Project Name: Madison County Schools - Madison Central Press Box Improvements

Project Number: 25-053

ADDENDUM NO. 01

1 ENLARGED SITE PLAN
1/16" = 1'-0"

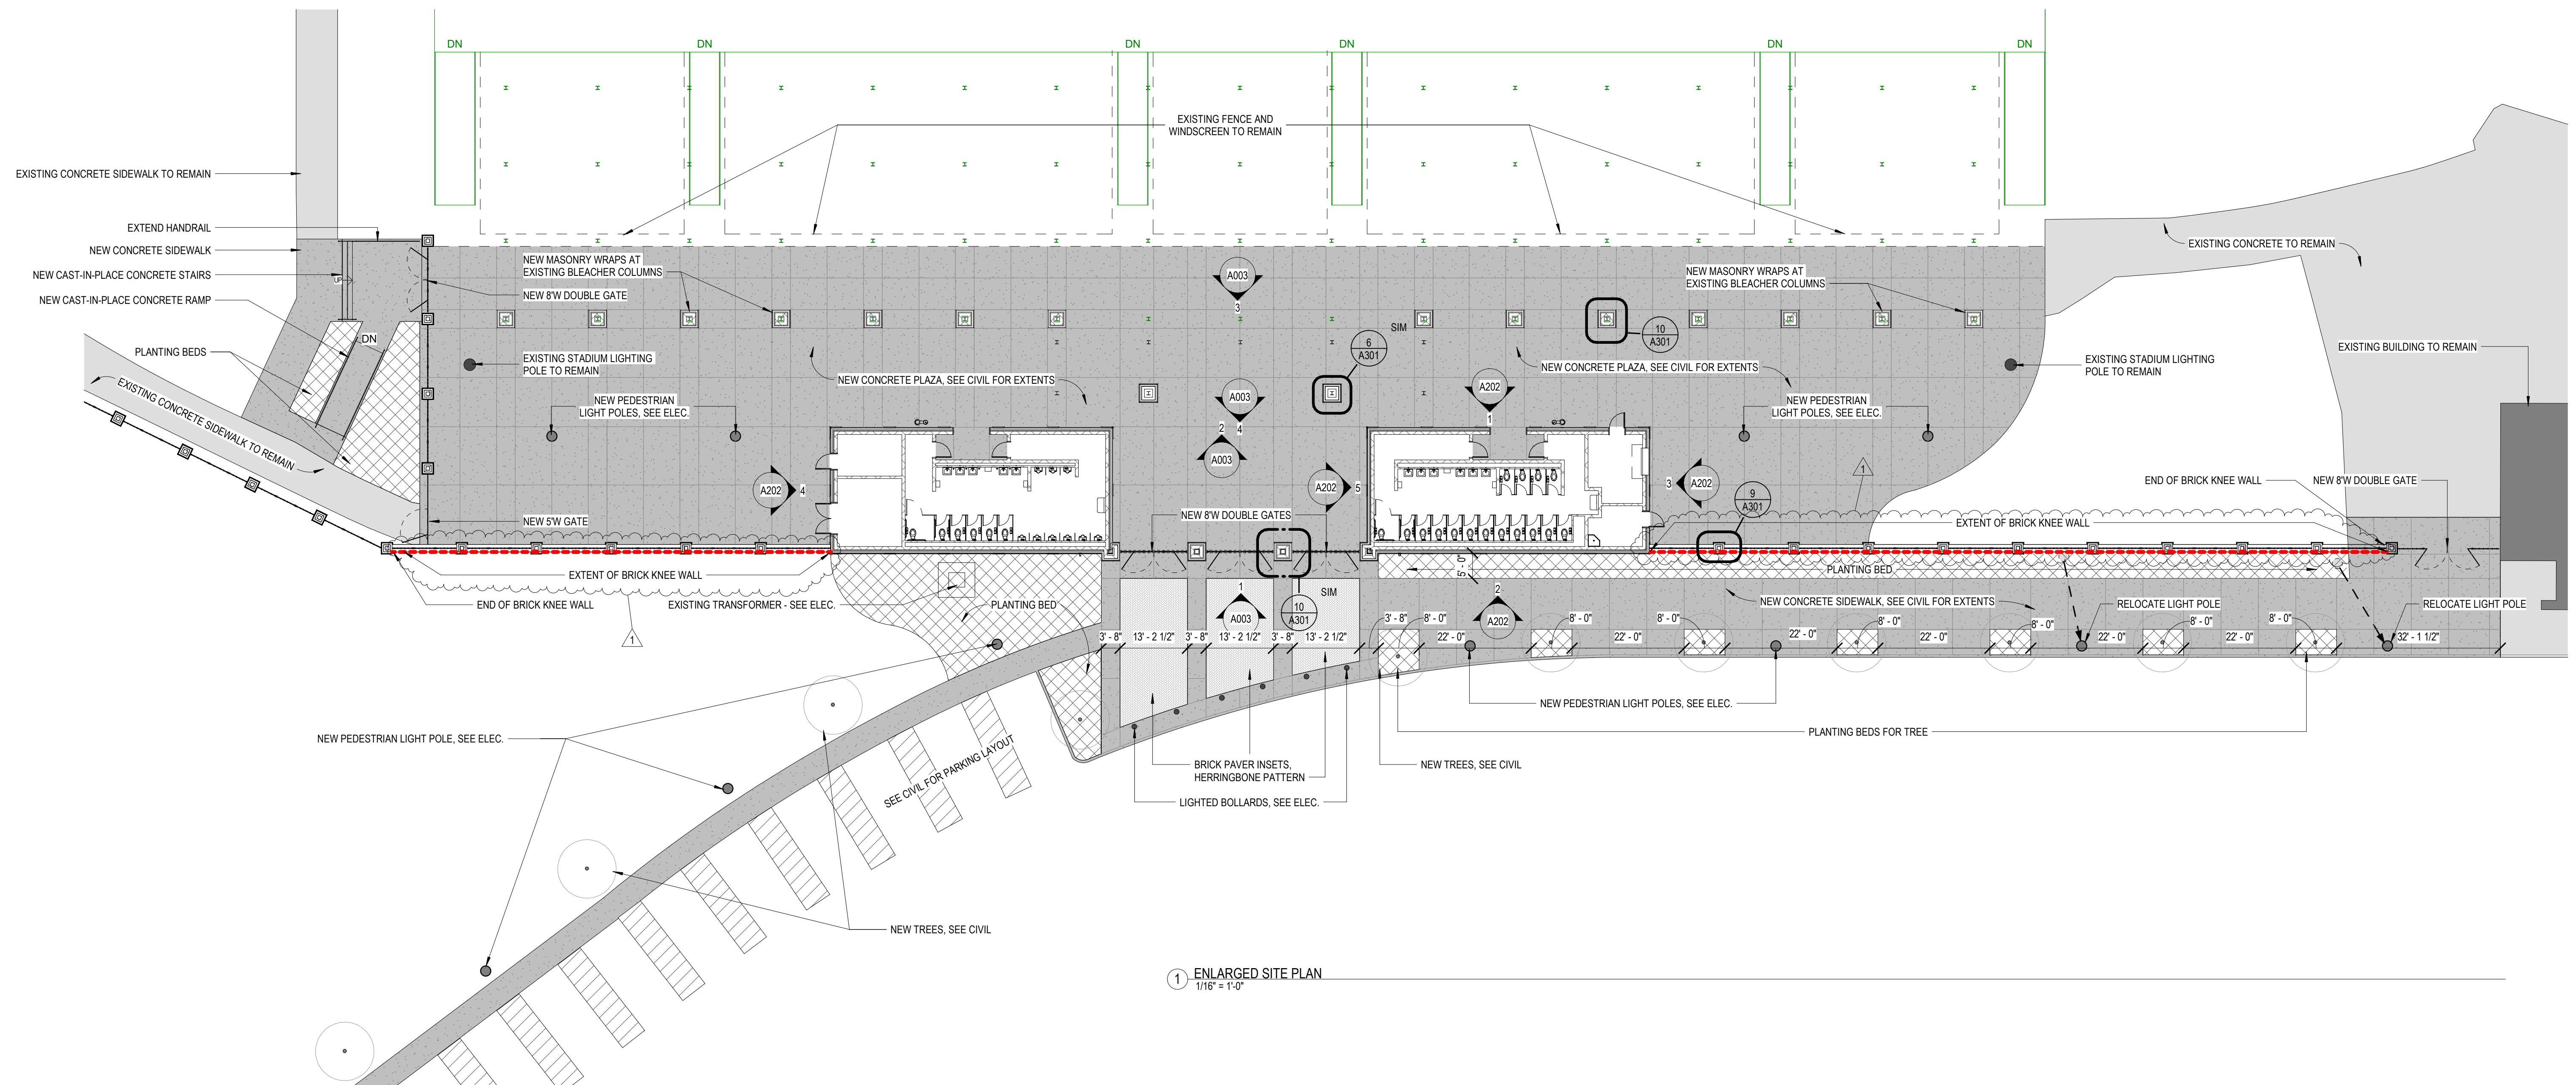
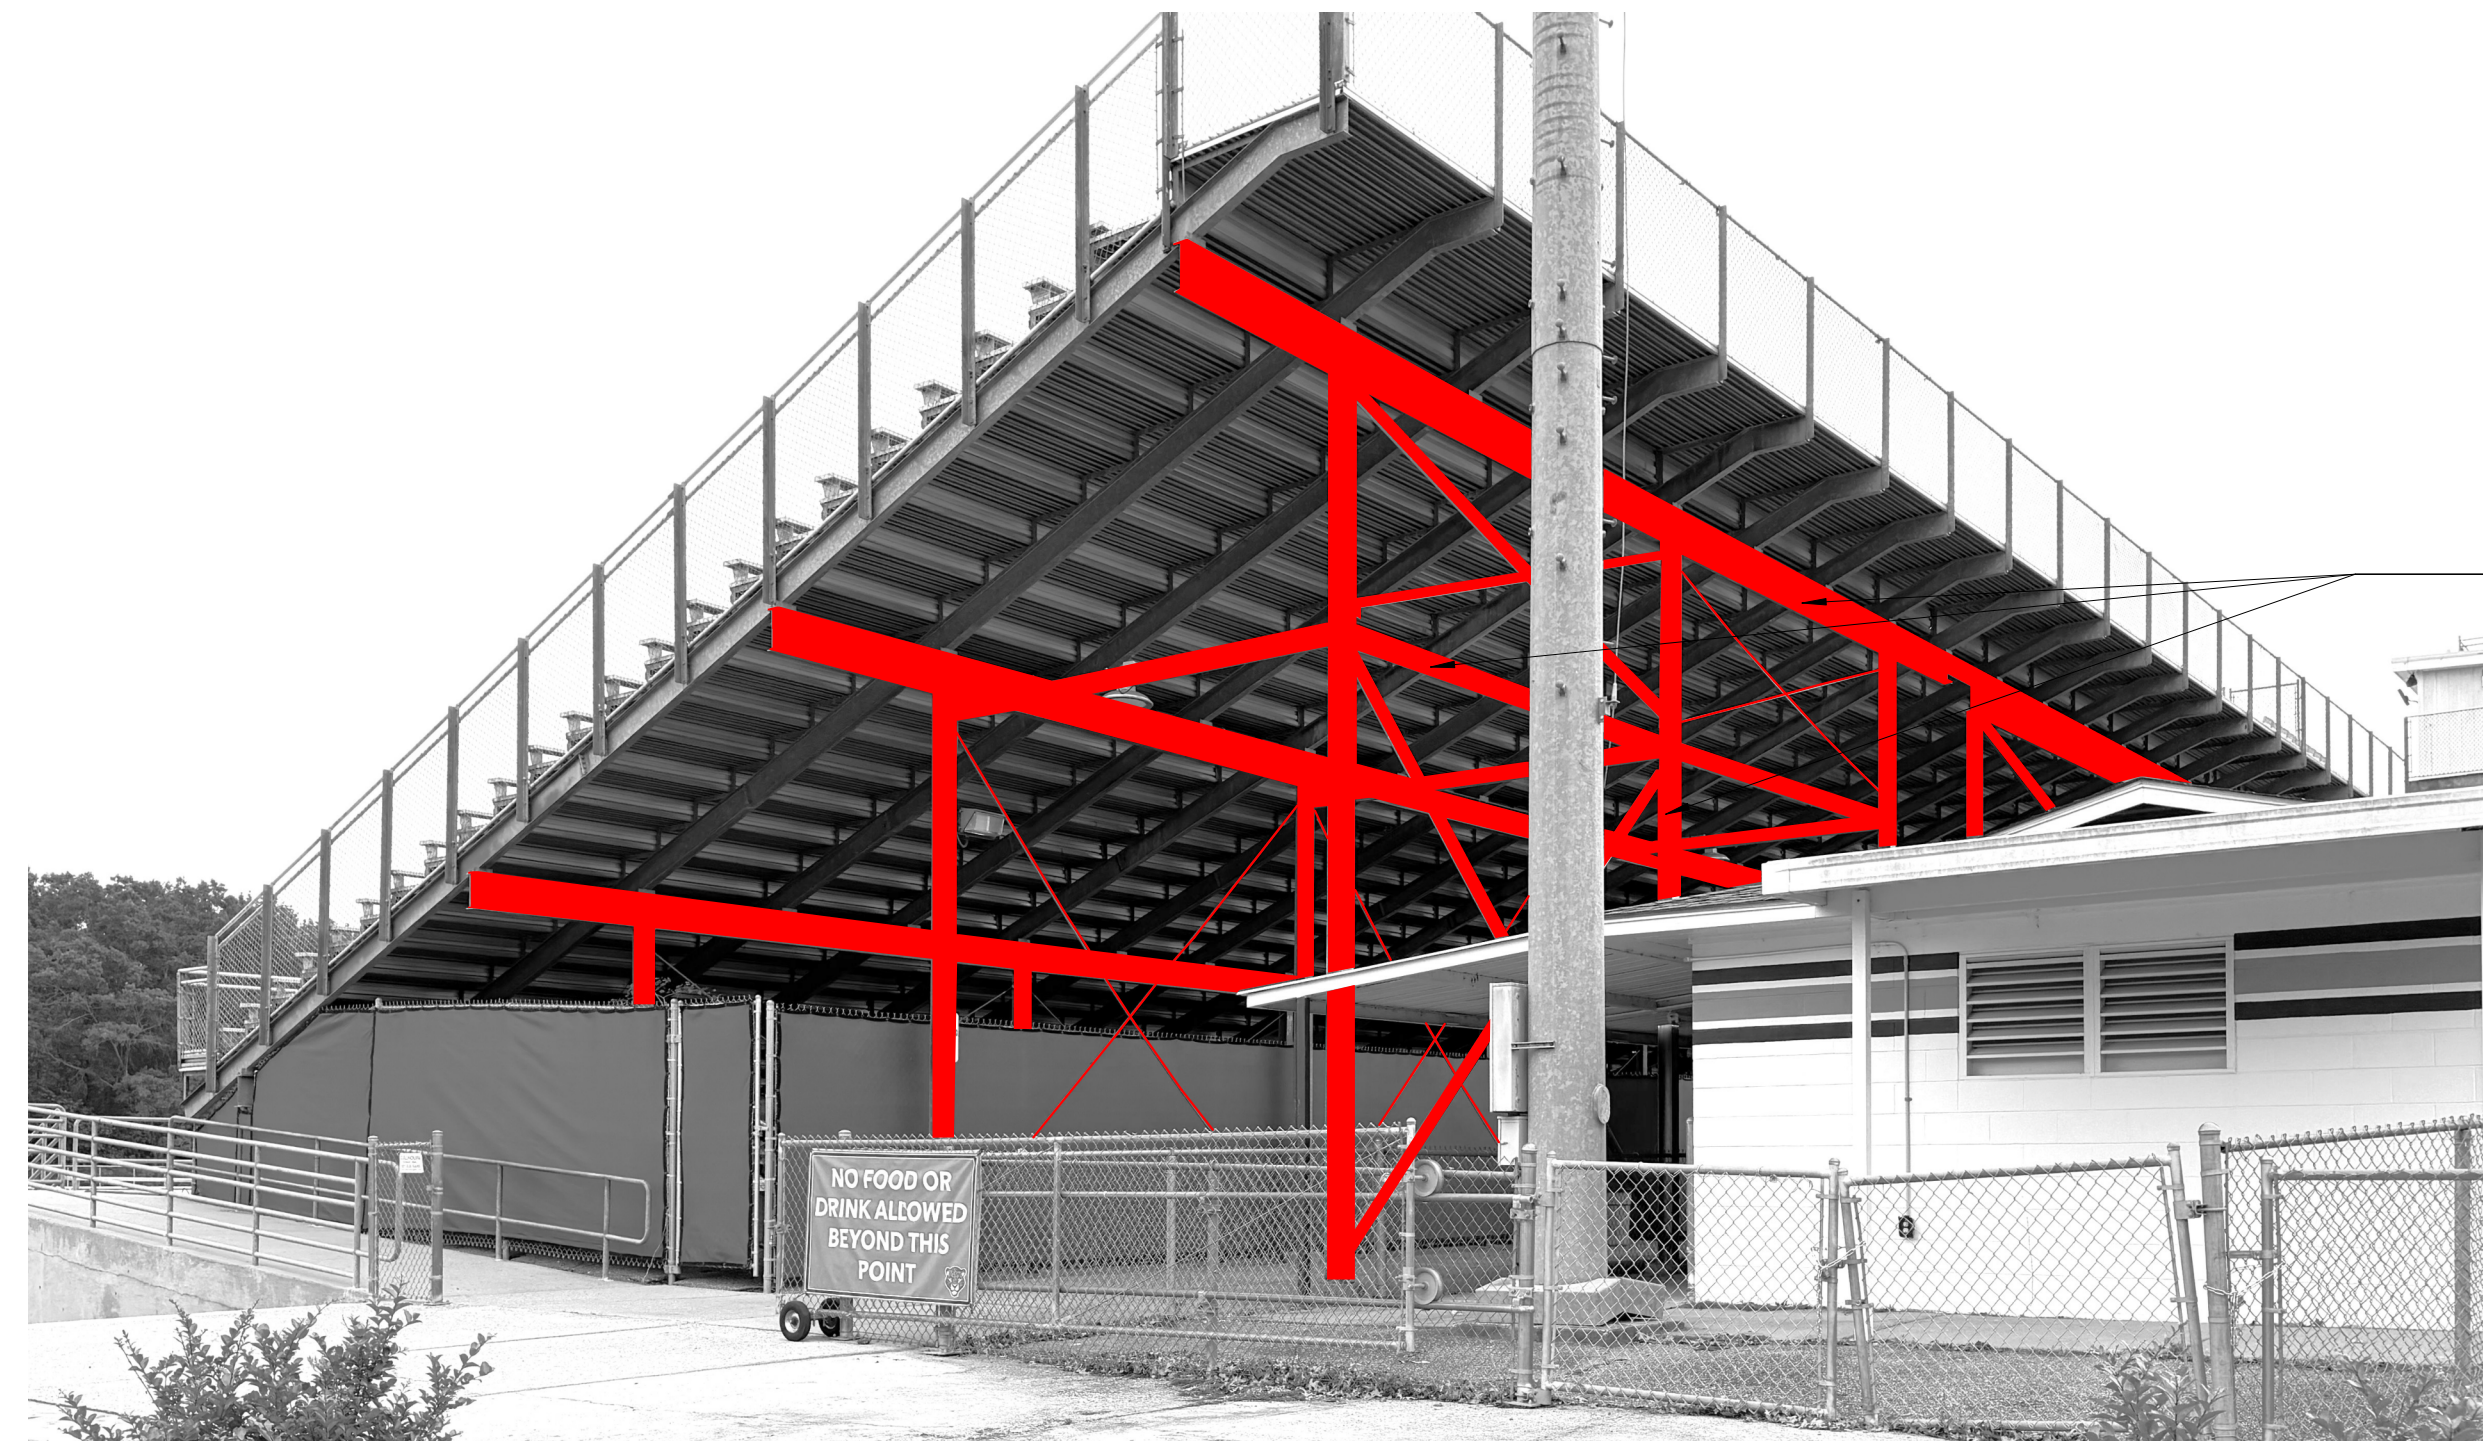
- ITEM NO. 21 **A002 ENLARGED SITE PLAN**
CLARIFICATION on the extent of the brick knee wall.
